QUESTION 110.1

SSES-FSAR

FSAR FIGURE 110.41-3

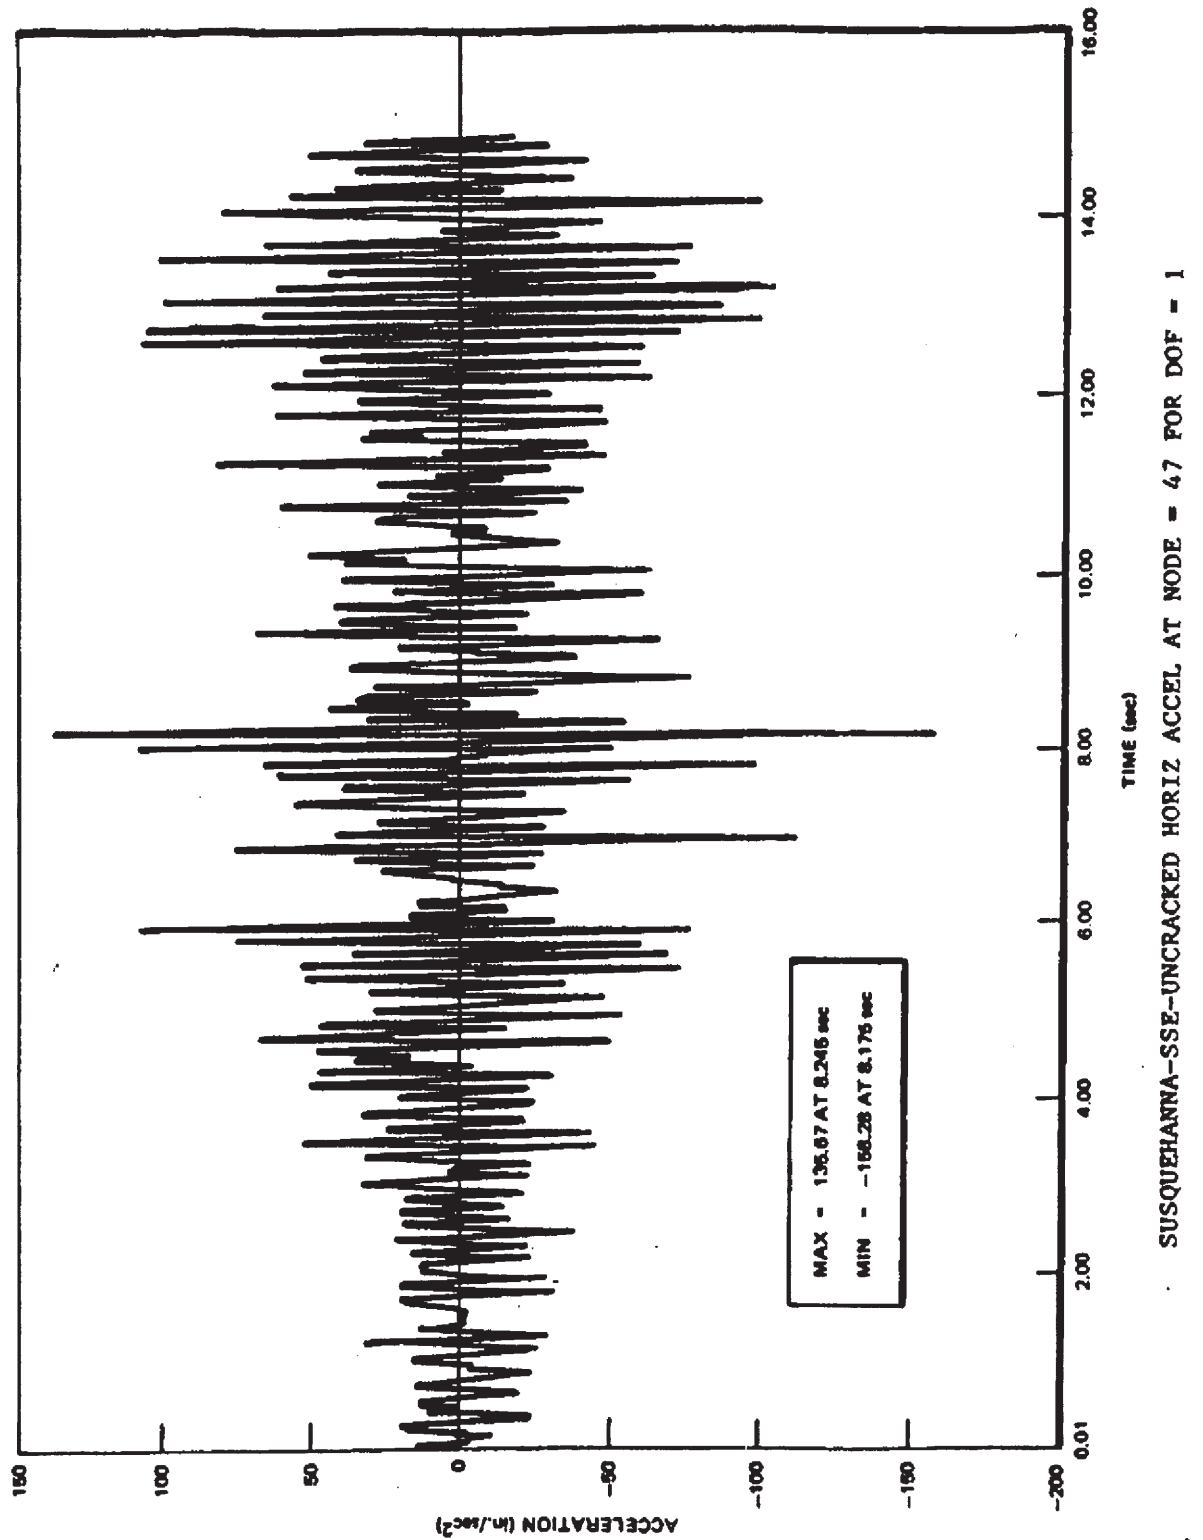
Provide the following additional information regarding the dynamic analysis of reactor internals under faulted conditions:

- a) Provide response time histories at one key location (having either the maximum stress combination or the most critical deflection combination, whichever is governing the design) for each of the following internal components:
  - (1) Jet pump
  - (2) Shroud wall
  - (3) Shroud head
  - (4) Control rod
  - (5) Instrumentation guide tube
  - (6) Core plate

For each location, separate response time histories for the various load effects associated with the SSE and most severe pipe break event should be provided.

- a) The following additional response time information for selected internal components under the SSE and the most severe pipe break accidents is provided.

Figures 110.41-3 thru 110.41-10 - Response time history plots due to horizontal SSE.
